SERVICE BULLETIN

Service Bulletin Number: SB-002

Subject: **HIGH PRESSURE Fuel Pump Replacement.**

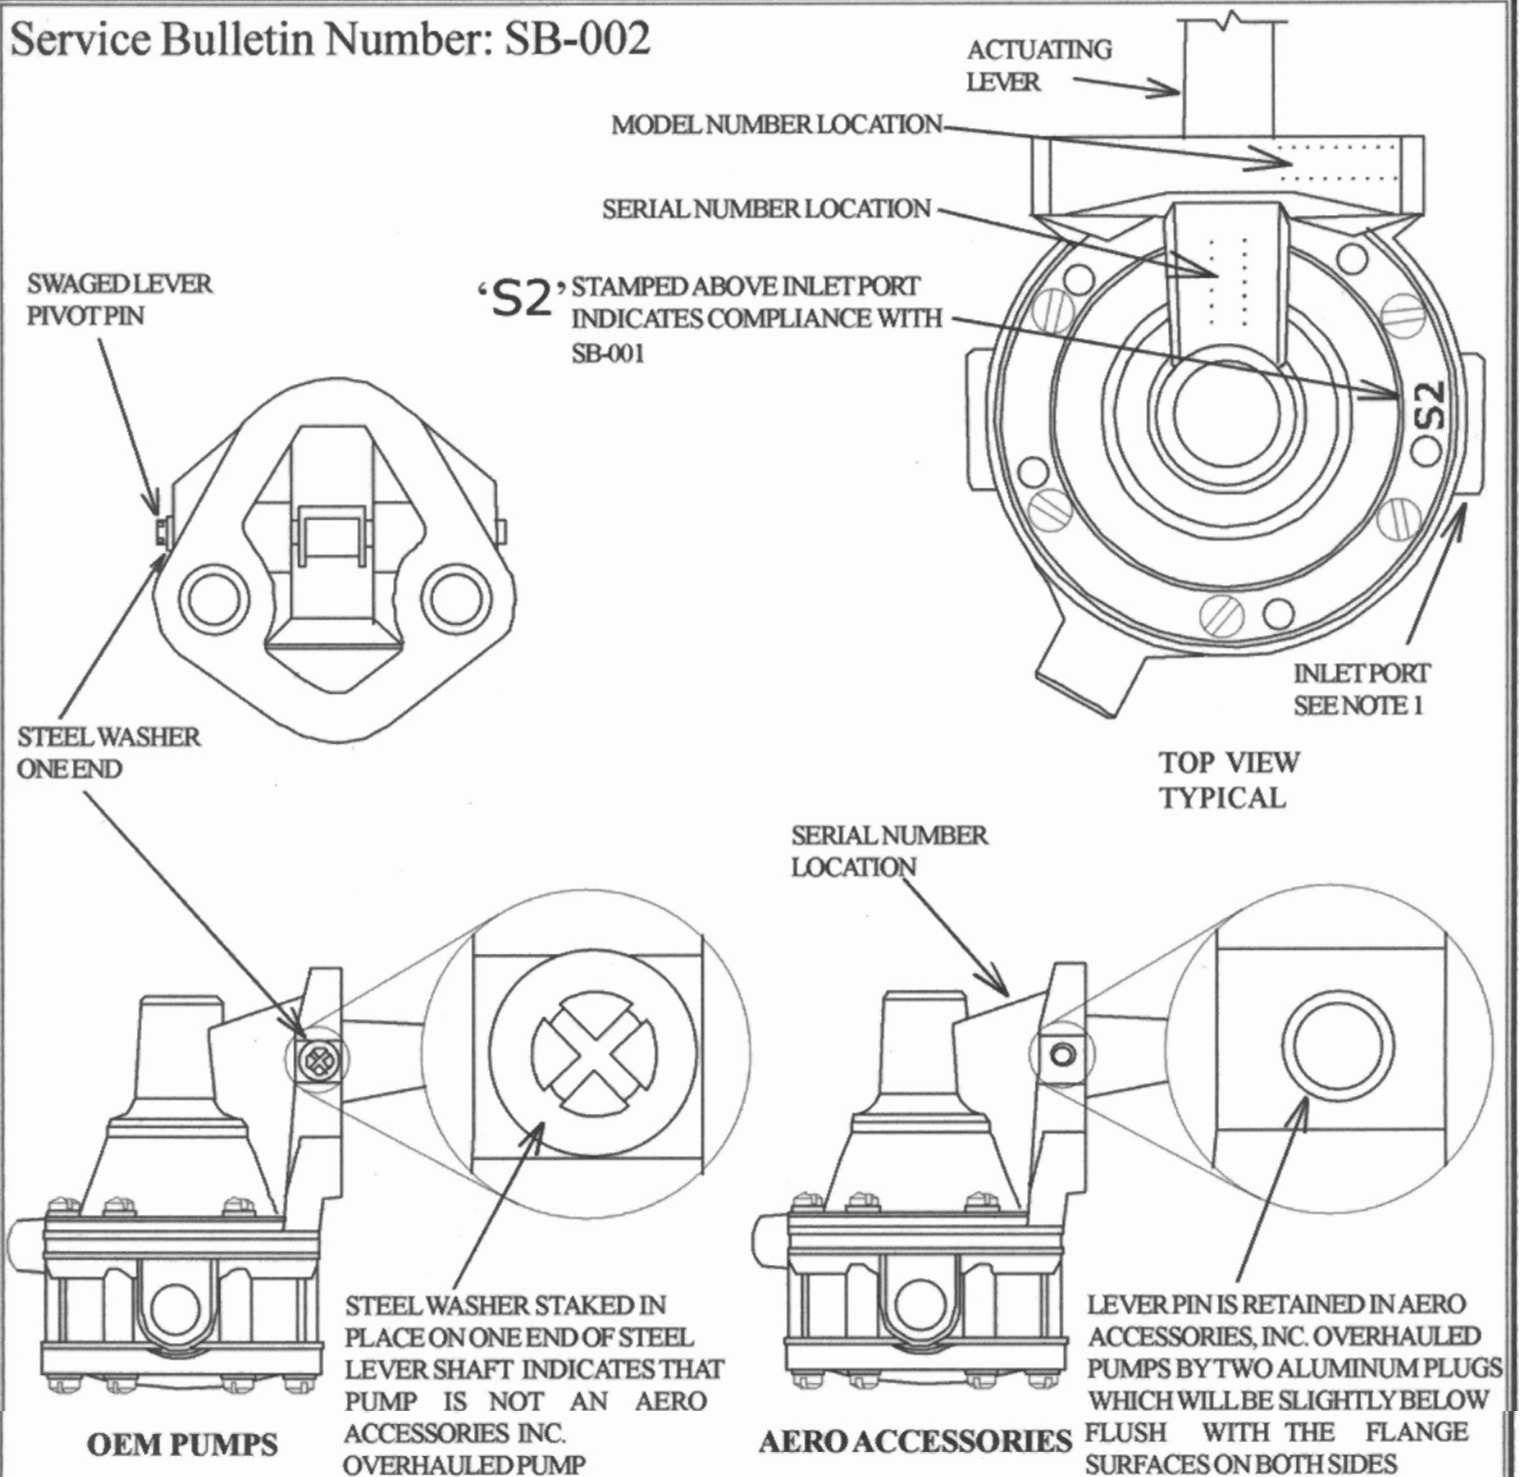
To prevent possible engine fuel starvation - all HIGH Pressure AC / Lycoming diaphragm type fuel pumps or Ray Jay (Rotomaster) diaphragm type fuel pumps serviced or overhauled by Aero Accessories, Inc. beginning on June 18, 1991 and ending on November 24, 1992, included in the above listing of model and serial numbers, must be removed from service immediately - before further flight.

Affected units listed above which are in compliance with Service Bulletin SB-002 will be identified by the characters 'S2' stamped as indicated on Page 2 of this Service Bulletin.
